ENTSO-E response to CEDEC on Interpretation of article 15 in NC DCC

External Project Team / WG CNC

29 May 2017

Title: Interpretation of article 15 in NC DCC – Belgian DSOs

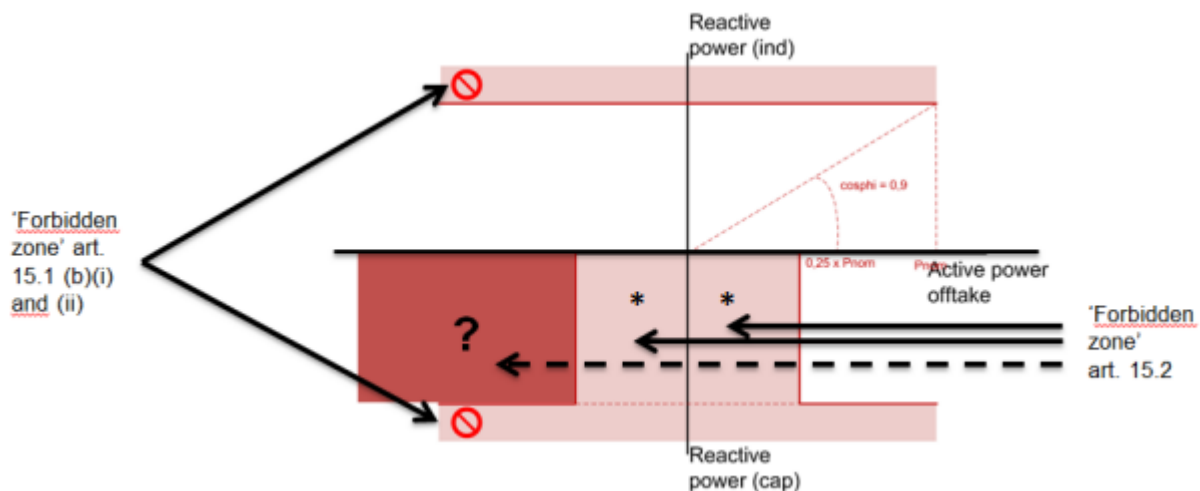
The connection point between a distribution grid and a transmission grid (typically a transformer station) will most probably always be a ‘mixed’ connection point. Power generating modules and demand facilities will be connected at the same connection point, not necessarily directly, but at least indirectly via the distribution lines connected to that connection point.

So, one could argue that article 15.1.f would be applicable to (almost) all connection points between the distribution and the transmission grid...

... but since the exact phrasing is not mentioned in plural but in singular (power generating module and demand facility) we conclude that the paragraph will not be applicable to the DSOs’ connections points to the transmission grid.

Can this latter statement be confirmed ?

As it is conceivable that the TSO/DSO interface, typically within a station, could also contain a PGM at the same connection point, the objective of Article 15(1)(f) is to clarify that the equivalent requirements to Article 15 would be required, i.e. net of the PGM.

The definition of the connection agreement and the connection point in the Network Code RfG are very explicit. Given these definitions it seems to be clear the Article refers to the situation as described above and not to all embedded generation (i.e. those beyond the connection point) within the DSOs network.

In the event of a generator application to the DSO that generator will be connected to the distribution network and thus become part of the distribution system, i.e. the network and the users connected to it. This system will be connected to the TSO network at the connection point via a connection agreement and therefore the generator will have a connection point to the Distribution system (and not the Transmission System). However the Distribution system will have a connection point to the Transmission system, and it will be required to ensure its system (network and users in totality) complies with the requirements at the connection point.
